Technical Bulletin

**Subject: Sill Panel Undercoating or Body Damage Due To
Contact With Hoist Lift Arms or Floor Jacks**

Number: 00-01

Model(s): TT Coupe

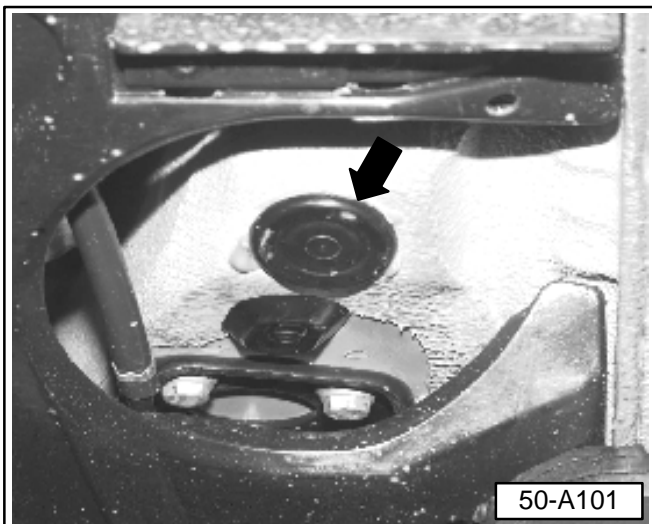
For vehicles without hoist lift point pads:

- Repair body damage or undercoating as necessary.
- Remove round body plugs -arrow- from both left and right sides of vehicle at front of vehicle.
- Install hoist lift point pads into these locations (pads must be fully seated, see installation instructions on page 2).

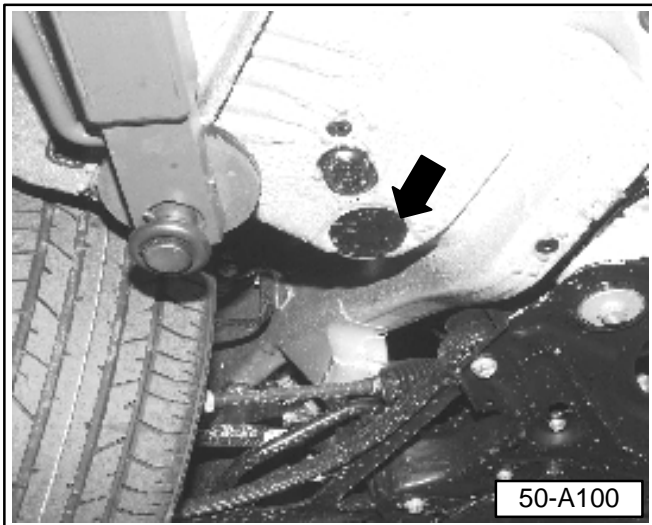
- Remove round body plugs -arrow- from both left and right sides of vehicle at rear of vehicle.
- Install hoist lift point pads into these locations (pads must be fully seated, see installation instructions on page 2).

Lift point pads, installing

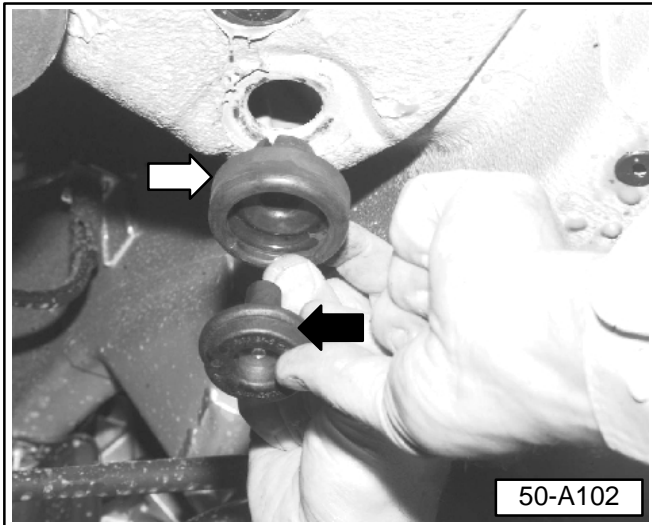
- Lubricate hoist lift point pad Part No: 8N0 804 583 with solution of soapy water. Tire mounting soap (available locally) works well.
- ◀ - Insert hoist lift point pad –white arrow– into holes (where body plugs were removed).
- Lubricate tapered lift point pad spreader, Part No: 8N0 803 855 with solution of soapy water.
- Insert tapered lift point pad spreader –black arrow–into lift point pad as shown. Press into lift point pad until fully seated.
